Current definition (1)

- The definition of *length* parameter in MA_CONTROL.request from Discovery Process to Gate Process at the TX side is not clear.
 - Description of D1.1 (P134 Figure 56-16)

Proposal (to 56.3.4.1)

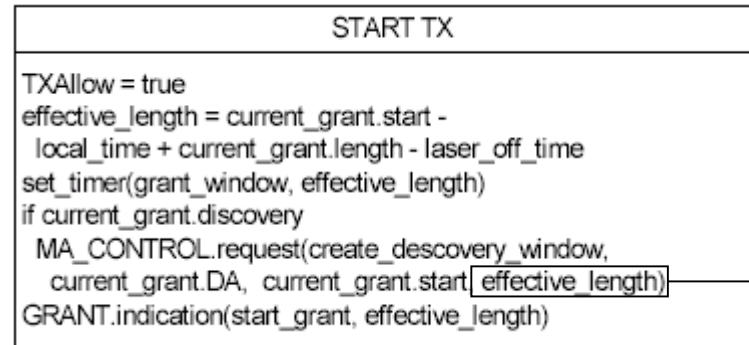
This parameter indicates the length of the allocated discovery window.
(P132 L34)

This parameter indicates the length of grant in the discovery GATE.

If this length is same as discovery_length, there is a problem shown in slide 4.

Case study of Discovery (1)

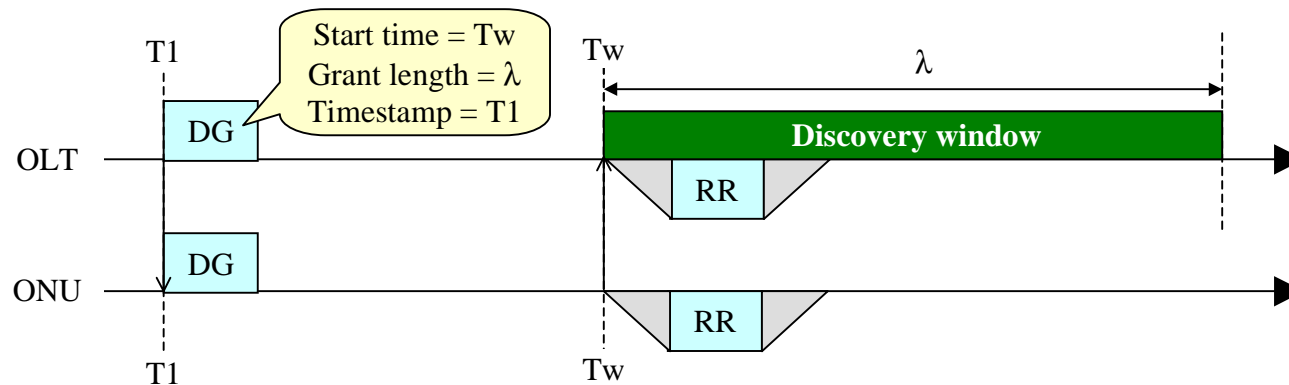
- Distance = 0, Random delay = 0
 - ➔ Assumption: Grant length = λ (same as the length of discovery window)

REGISTER_REQ can be received at the beginning of discovery window.

Case study of Discovery (2)

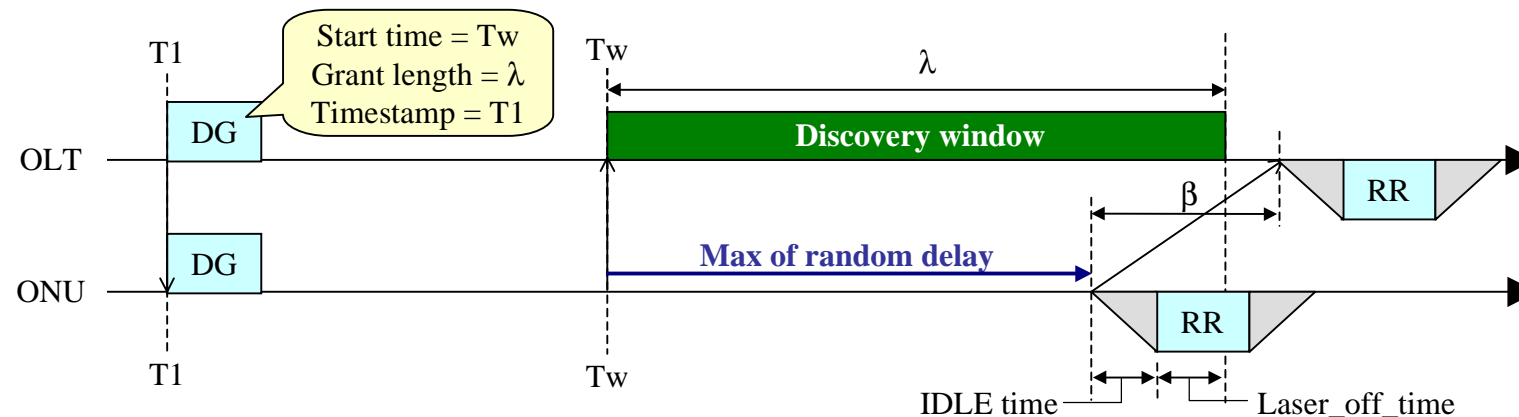
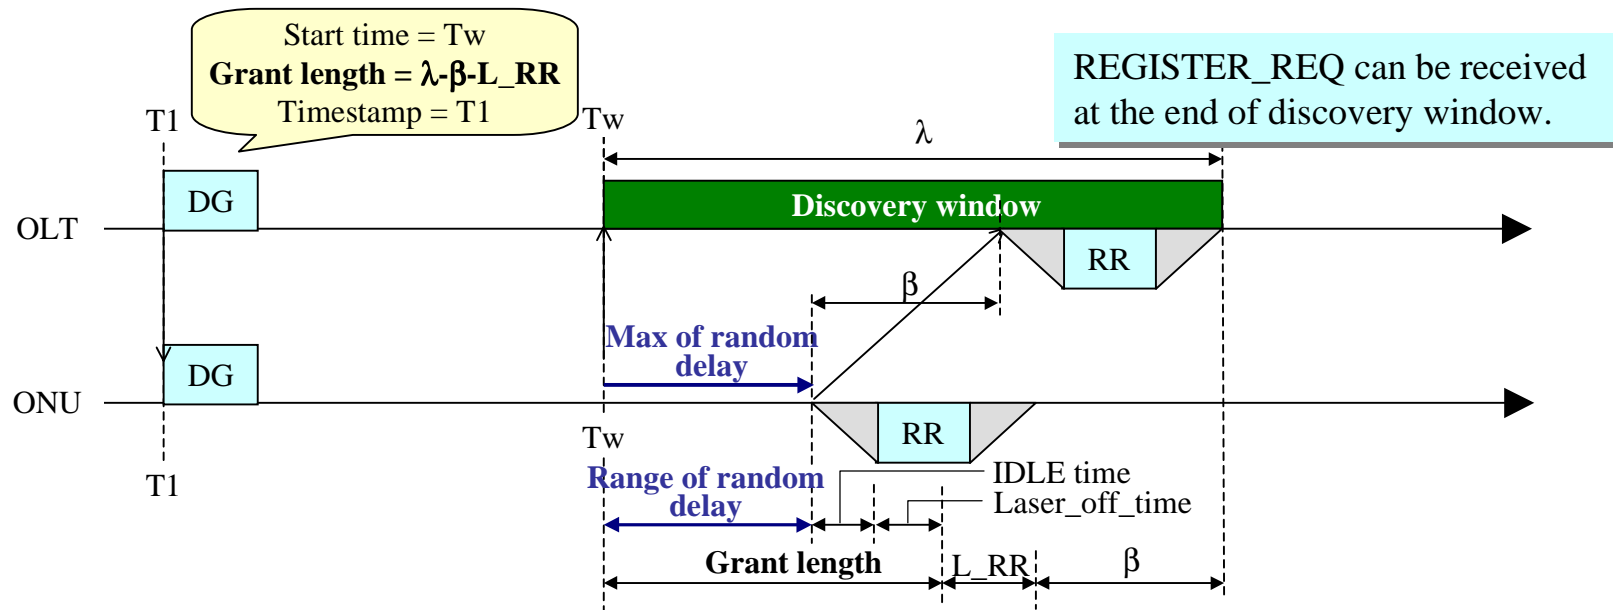
- Distance = $L(>0)$, Random delay = max
 - The maximum random delay is $\lambda - (\text{IDLE time} + \text{laser_off_time})$.
 - ➔ Refer to slide 5.
 - ➔ Assumption: Grant length = λ (same as the length of discovery window)

REGISTER_REQ cannot be received within the discovery window.

- On the OLT side, not only the length of allocated discovery window but also the length of discovery gate should be indicated by the client.
 - Two types of MA_CONTROL.request (create_discovery_window) should be specified. One is for OLT, another is for ONU.

- MA_CONTROL.request (create_discovery_window) primitive for the OLT should have additional parameter *grant_length* which indicates the length of the discovery gate in *time_quanta*. This parameter is mapped into *length* parameter in MA_CONTROL.request primitive in SEND REGISTER WINDOW state.

- The client calculates the length of the discovery gate. The value is equal to or less than “ $\lambda - \beta - L_{RR}$ ” in *time_quanta*. λ indicates the length of the discovery window, β indicates the round trip propagation delay of the farthest ONU, and L_{RR} indicates the length of REGISTER_REQ including IPG and preamble (i.e. 84 octets), respectively. (See next slide.)

- The Grant length in the Discovery gate should be equal to or less than $\lambda - \beta - L_RR$.
 - λ : The length of Discovery window
 - β : The round trip propagation delay
 - L_RR : The length of REGISTER_REQ including IPG and preamble
